Subject: DA2020/0865 - 41 Heathcliff Crescent, Balgowlah Heights - Submission

Submission in response to the Development Application DA2020/0865 at 41 Heathcliff Crescent, Balgowlah Heights

Figure 2 — Ground Floor Plan of 39 Heathcliff Crescent, depicting the locations of primary internal living spaces.

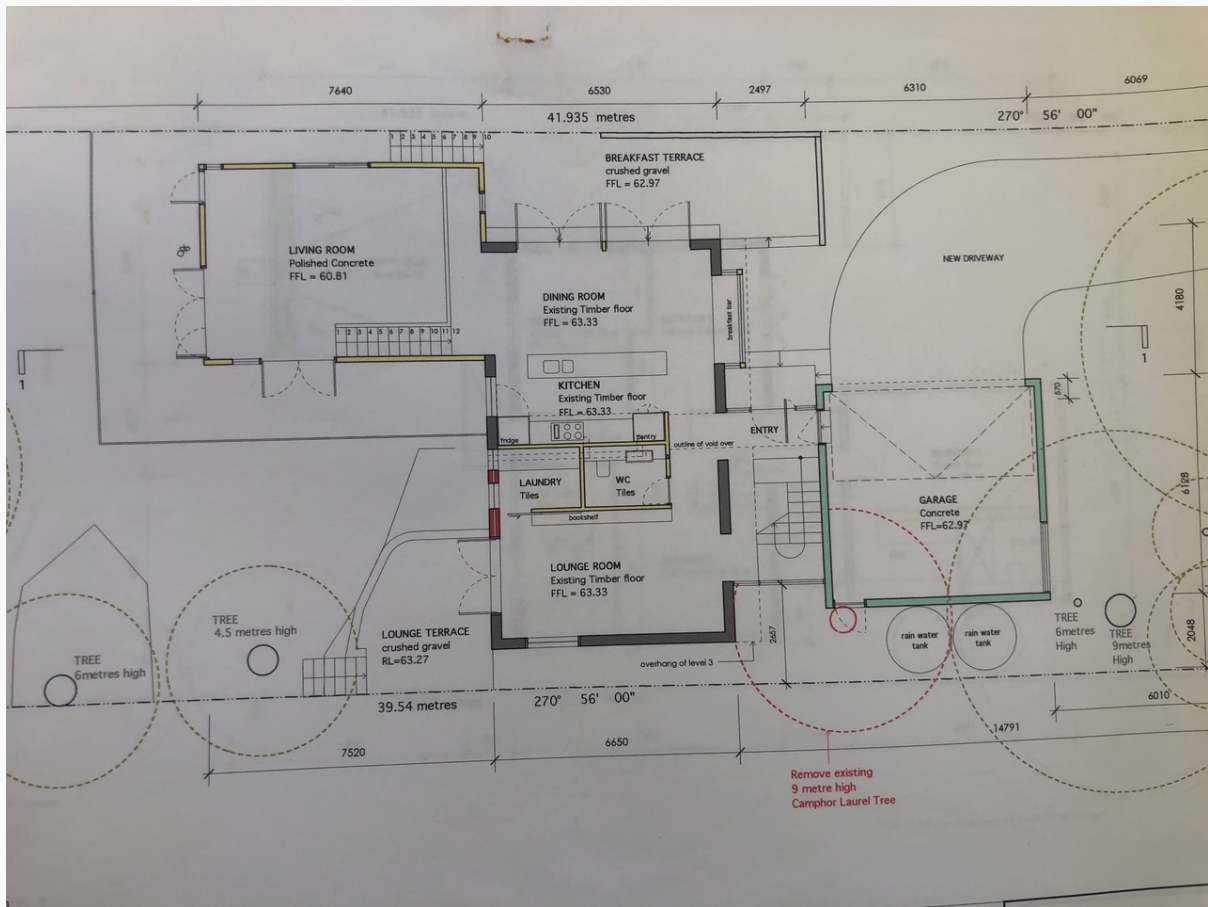
Understandably, our Clients concern is the substantial loss of solar access presently enjoyed to their primary internal living spaces, that have been designed to carefully balance passive design. The potential impact of the Application could threaten these spaces, materially affecting their amenity.

The Submission notes that at present, the proposed Development results in some solar access being provided to the openings of the living spaces at the North Elevation of 39 Heathcliff Crescent, but the Submission questions the quality of this solar access relative to existing solar access. Without the provision of Existing Shadow Diagrams, a sound assessment of the Development's impact cannot be fulfilled.

1. That Existing Shadow Diagrams be provided between the hours of 9:00am and 3:00pm on June 21 in Plan and Elevation or Oblique View.
2. That the gabled roof over the Balcony be deleted and replaced with a shallow skillion awning or similar design that improves solar access to 39 Heathcliff Crescent.
3. That the side boundary setbacks be increased to achieve compliance with Part 4.1.4 of the MDCP2013.
4. That the Balcony be reduced as recommended above.
5. That the solar access provisions of Part 3.4.1.2 of the MDCP2013 be upheld.

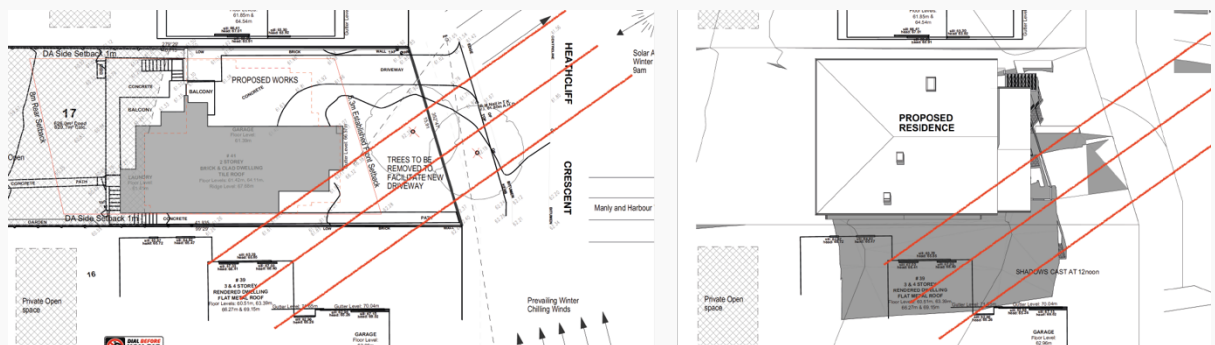
Our Client acknowledges and supports the Applications proposed scheme that will undoubtedly improve their current views to a similar extent as that illustrated above, but is concerned by the negligence of the Application to seriously consider view loss from 39 Heathcliff Crescent. Reference throughout the Statement Of Environmental Effects, such as “the proposal will not have any detrimental effects on views” (Page 14), and “the proposal does not unreasonably obstruct any significant views from private property” (Page 16), and “the proposed dwelling has been designed to allow for views to be enjoyed past the dwelling for properties to the south” (Page 16) and that “consideration has been given to the existing outlook for the adjoining property at No 39 Heathcliff Crescent, which enjoys views across the eastern portion of the site towards Manly” (Page 19) is alarming, and serves as evidence that no significant value or consideration is made to share existing views, or that a thorough assessment against the matter of Tenacity Consulting v Warringah Council [2004] NSWLEC 140 is made.

The salient matter of concern for our Client is the extent to which the Development will share its views, or take it away for their own enjoyment. In considering view loss, the Submission briefly utilises the Planning Principle to assess the Development:

1. That a View Share Analysis be undertaken to assess the impacts of the proposed development.
2. That height poles be erected at 41 Heathcliff Crescent by a registered Surveyor, for the Consent Authority to assess potential view loss.
3. That the First Floor Balcony be reduced in extent and reconfigured, as proposed above, to manage view loss.
4. That the proposed Garage be reduced in depth to 5,400mm to comply with the minimum standards of AS2890.1-2004, that will increase the front boundary setback of the south-east corner of the proposed Garage, to facilitate existing views from the primary internal living spaces of 39 Heathcliff Crescent.
